Land to rear of
112-156B Harpenden Road
St Albans
Hertfordshire

Non Material Amendment - Changes to off-site highways works of planning permission 5/2021/0423 dated 12/01/2022 for Outline application (access sought) - Residential development of up to 150 dwellings together with all associated works

(LPA Ref. 5/2023/1426)

Transport Note 6021/1

Figure 1 Extract from "St Albans City and District Cycling Map" (July 2019)

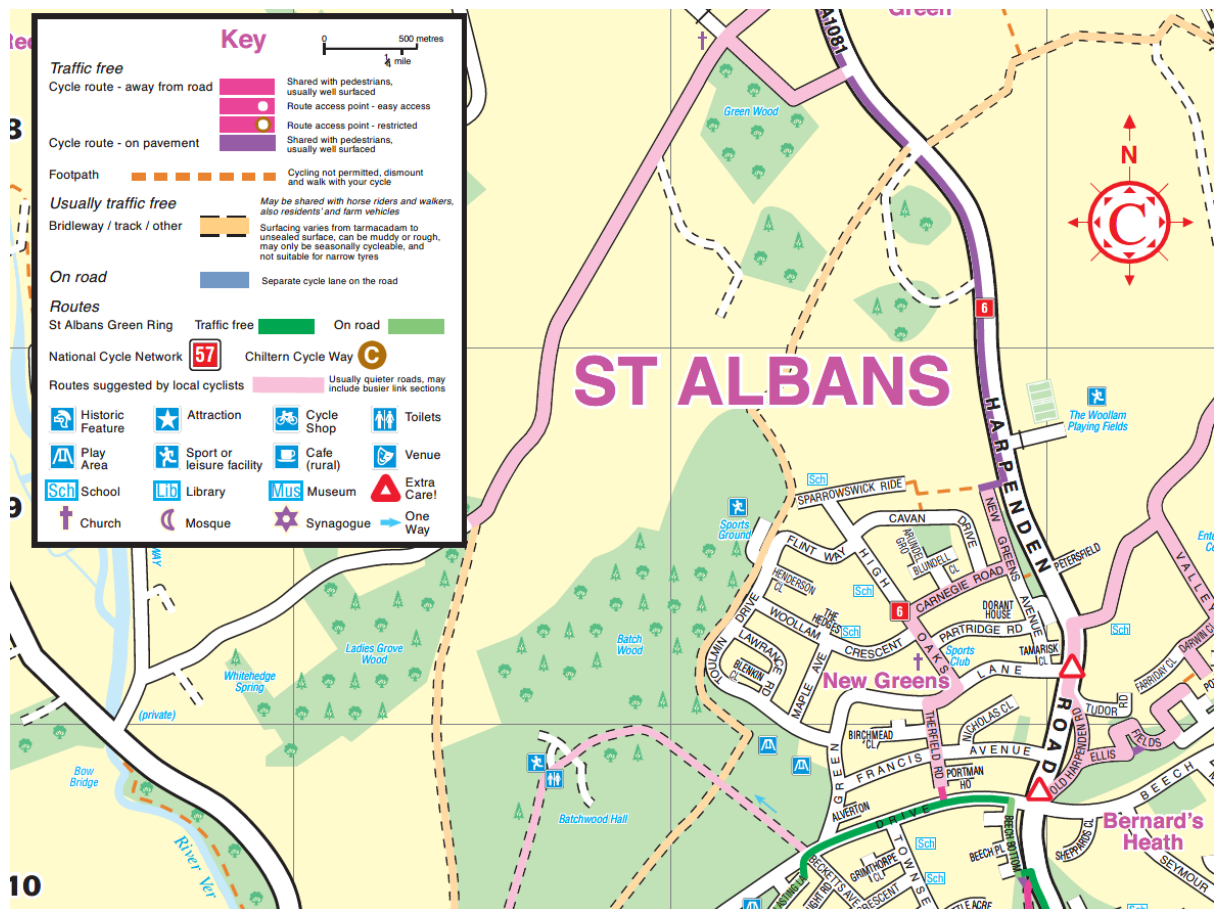
- National Cycle Route 6 routes along Harpenden Road to the north of the study area but then diverts onto the minor residential roads to the west before rejoining Harpenden Road to the south of the Harpenden Road/Beech Road/Batchwood Drive signal controlled junction.
- The southbound cycle route diverts off Harpenden Road onto Old Harpenden Road before rejoining Harpenden Road at the signal controlled junction.

- The section of Harpenden Road to the north of the signal controlled junction is identified on the map as being an area where cyclists should take “extra care”.

4.4 It is clear therefore that the section of Harpenden Road that is the subject of the current planning application is a section of highway that has already been identified as being dangerous for cyclists.

4.5 The area identified as being particularly dangerous i.e. the hill to the north of the signal controlled junction, is the section of highway where the developer is now proposing to reduce the overall standard of provision for cyclists and pedestrians in conjunction with reducing the carriageway width along this section of Harpenden Road.
